## FIRMWARE RELEASE NOTE

## Two-Wire IP Video Intercom Firmware Release Notes Build 180821

Supported Models DS-KH8340-TCE2	Firmware Version	DZ20171020_052_21_E3_EN_STD_V1.4.45_180821.zip
Supported Models DS-KV8103-IME2	Firmware Version	DZ20171020_052_21_A1_EN_STD_V2.0.0_180821.zip
iVMS4200 Version		V2.7.1.9 build 20180604

**5. Added additional door station settings in the SADP menu.**

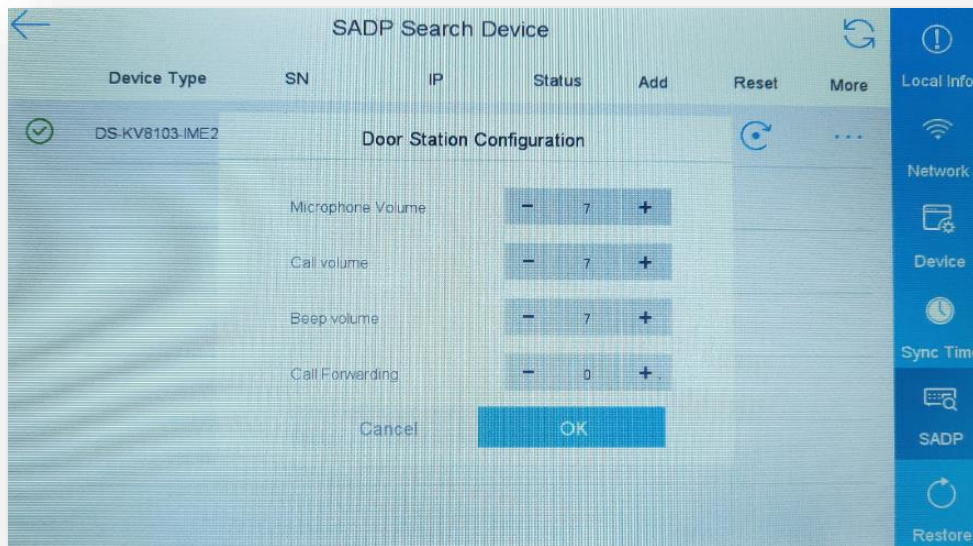
In Settings->Configuration->SADP click the "More" button next to the door station to configure:

- Microphone volume
- Call Volume
- Beep (system sounds) volume
- Call forwarding delay to the Hik-Connect app
